#### **ADDENDUM NUMBER THREE (3)**

**Project: Sugar Creek Emergency Sewer Repair – FY25**

Owner: City of Valdosta, Georgia

**C-5**

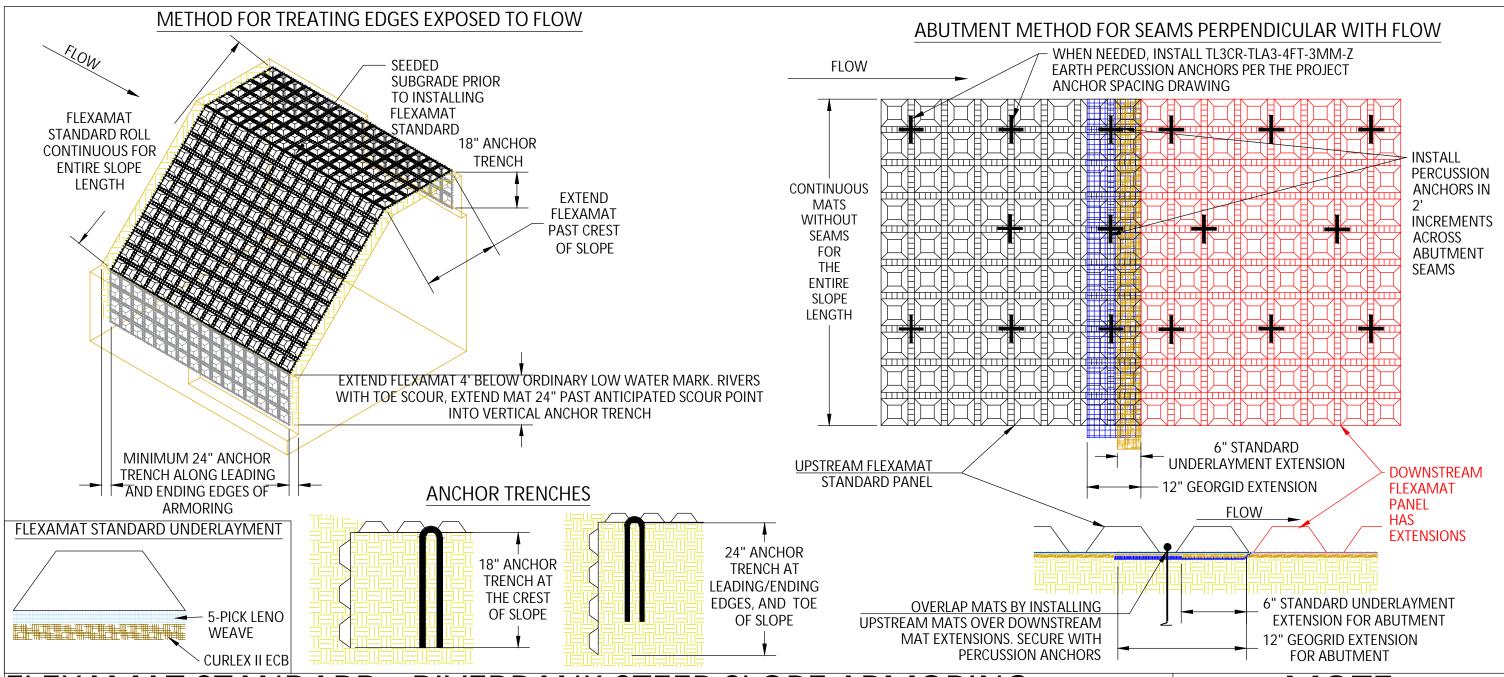
- 5. Tied concrete block mat stream bank reinforcement (Flexamat Standard or equal) was added to stream banks at the 8" gravity sewer crossings shown on sheet C-5.

- 6. Alignment was adjusted at Station 7+50 to provide more clearance from the Georgia Power pole. This adjustment also includes relocating the existing rip rap and flared end section, and extending the 48" HDPE storm pipe.
